Re: Wastewater System Improvements Project  
Garden City, South Dakota  
A-9512  
SRF: C461341-01

### **ADDENDUM NUMBER 1**

**LIFT STATION IMPROVEMENTS SHEET**

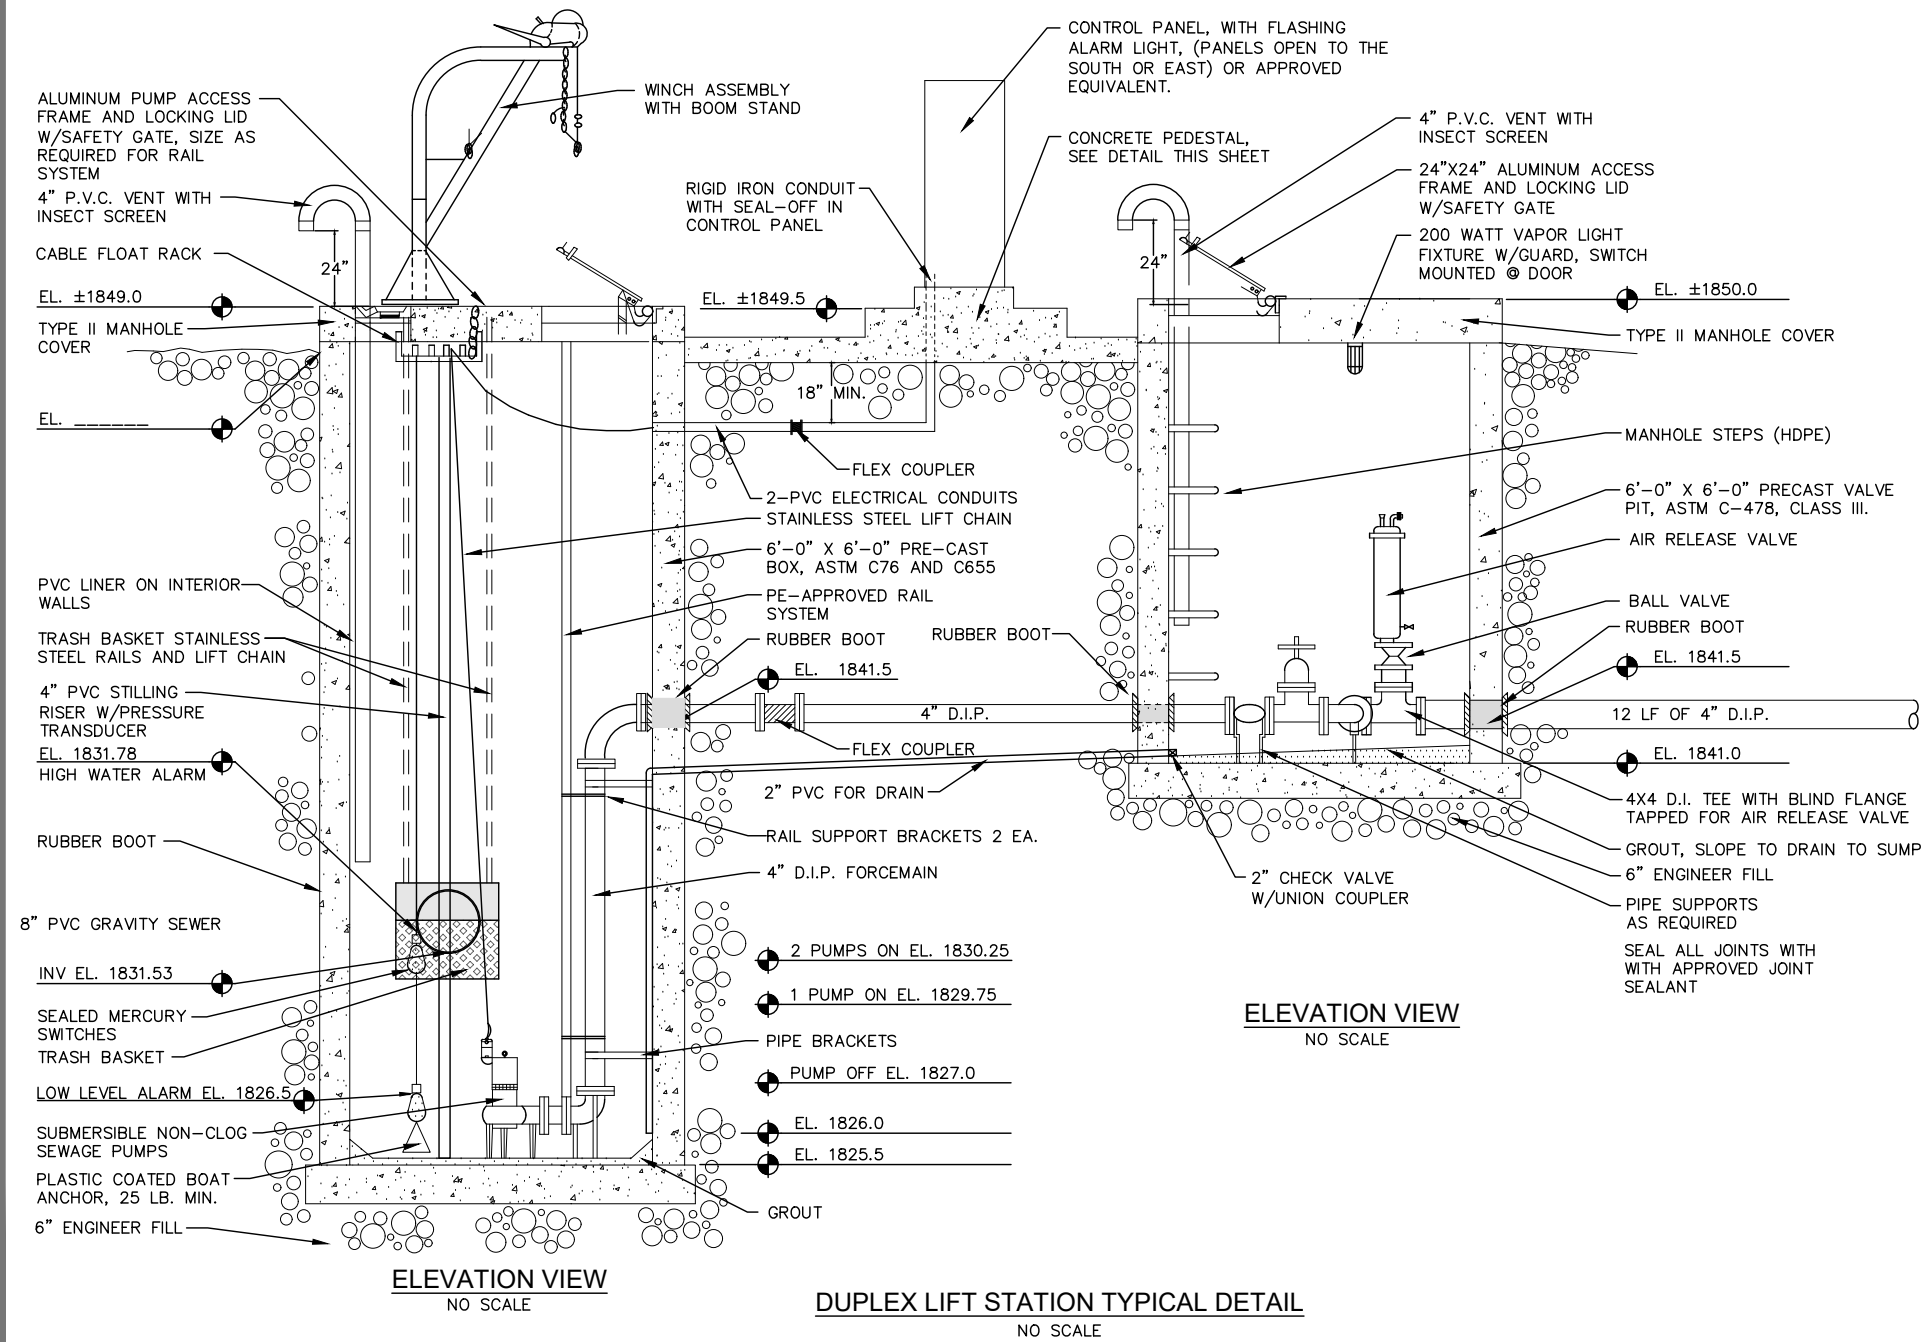
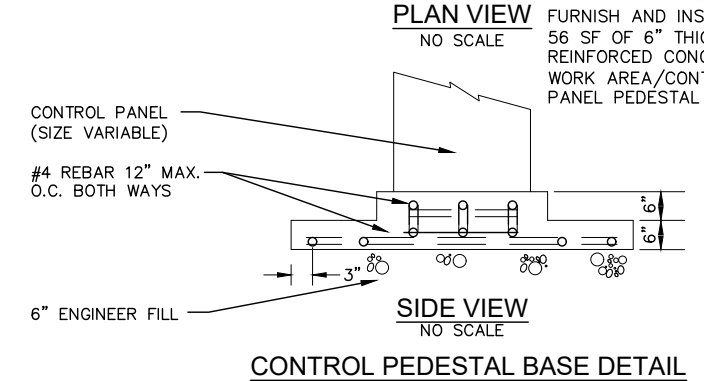
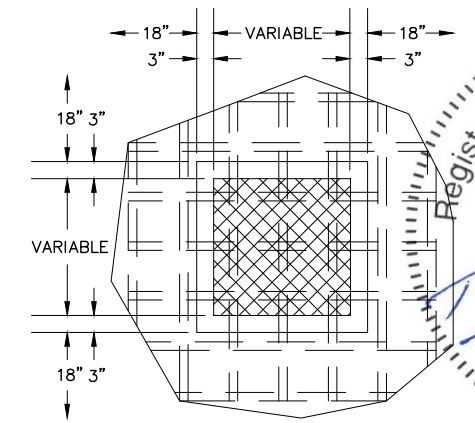
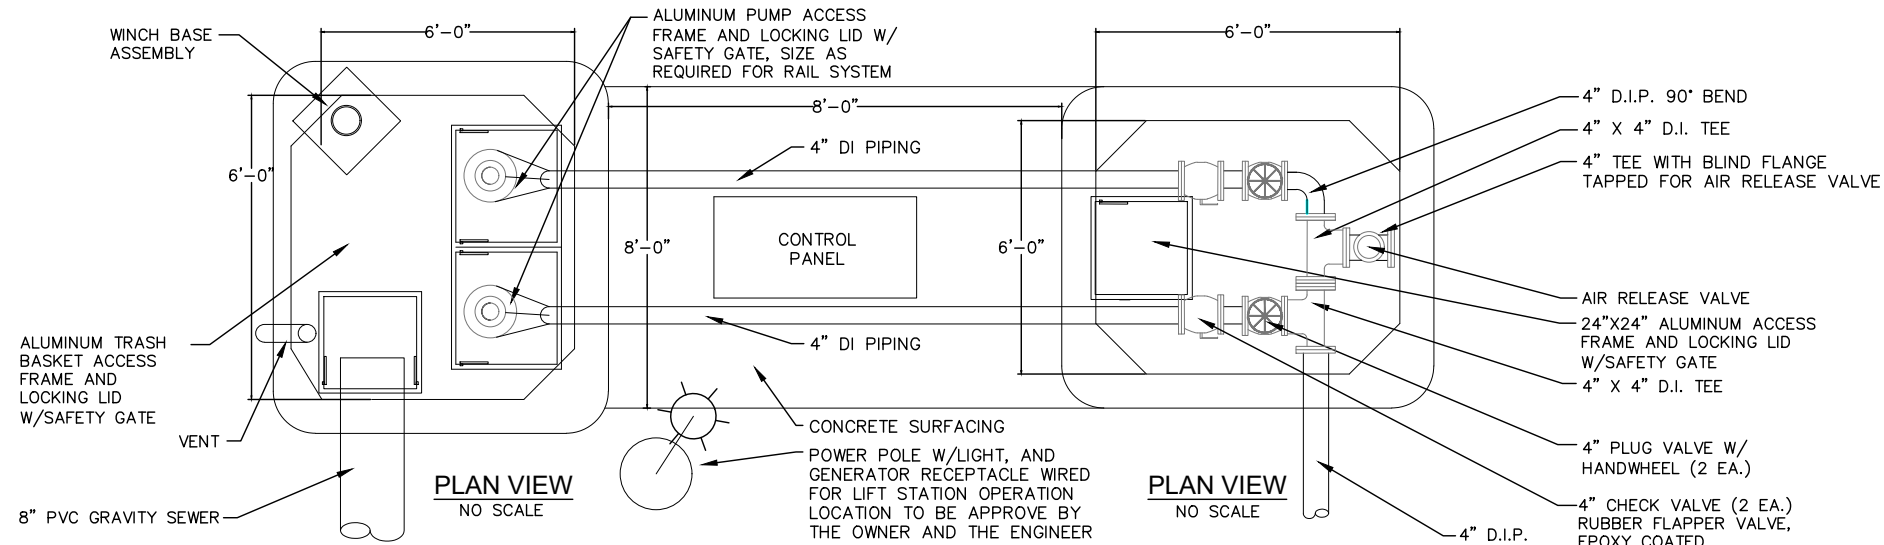
Registered Professional Engineer  
 No. 11037  
 1 Update to Layout of Lift Station 5/15/26  
 8/22/2025
